**PR/0090/23**

## Record of Executive Business and Chief Executive's Order

**Reg. Reference:** SD22A/0135      **Application Date:** 05-May-2022  
**Submission Type:** Additional      **Registration Date:** 20-Dec-2022  
Information

**Proposed Development:** Two storey construction (366.2sq.m) comprising of a two storey own door Coffee Shop (133.80sq.m) with connection to existing Centra' 2 own door ground floor shops to the rear of 48.0sq.m each with 2 first floor offices above of 48.0sq.m each; new pedestrian footpath and all associated site works.

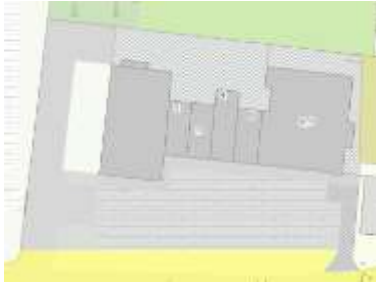
*The roads and paths within Whitechurch Shopping Centre are private (grey shade above). The road markings are non-existent or have worn away completely and Roads Department have significant concerns regarding a number of issues here.*

*The applicant must provide information relating to the existing parking or traffic arrangements, and consent from the owner of the centre re the use of the roads and existing parking spaces. The applicant shall provide 5% of vehicular parking spaces for mobility impaired users, and 10% vehicular parking spaces to be equipped with electrical charging points, REASON: In the interest of sustainable transport.*

*The applicant shall provide a drawing which demonstrates how pedestrians move safely within the shopping centre, and especially within the carpark (pedestrian crossings, kerbing, dished kerbing, footpaths, etc).*

*The applicant shall provide a drawing which demonstrates how bin trucks will access the development, and where bin storage will be located for all proposed units.*

1. *The applicant must provide:*
  - a. *a TTA (Traffic & Transport Assessment) Report with information relating to the existing parking and traffic arrangements (including the existing number of parking spaces in the centre, no. of trips, peak demand etc).*

- b. *a detailed drawing showing the traffic priority (with requisite road markings and signage) where the church entrance and shopping centre entrance occur.*

- c. *consent from the owner of the centre re the use of the private roads and existing parking spaces.*
2. *CDP 2016-22 Table 11.23 & 11.24 – Max no. carparking spaces to be provided. The applicant shall provide a drawing with the calculated number of car park spaces to be provided:*

- *5% of these parking spaces for mobility impaired users*
  - *10% parking spaces to be equipped with electrical charging points.*
3. *The applicant must provide a drawing with the calculated number of bicycle parking spaces shown. Calculations made using anticipated staff and seat numbers to be included. CDP 2016-22 Table 11.22 Min Bicycle Parking Rates.*

4. *The applicant shall provide a drawing which demonstrates how pedestrians will move safely within the shopping centre, and especially so within the carpark (pedestrian crossings, kerbing, dished kerbing, footpaths, etc).*

5. *A TIC dwg must be provided showing any areas that are intended to be offered for Taking in Charge.*
6. *The applicant shall provide a drawing which demonstrates how emergency vehicles will access the development.*

7. *The applicant shall provide a drawing which demonstrates how bin trucks will access the development, and where bin storage will be located for all proposed units.*
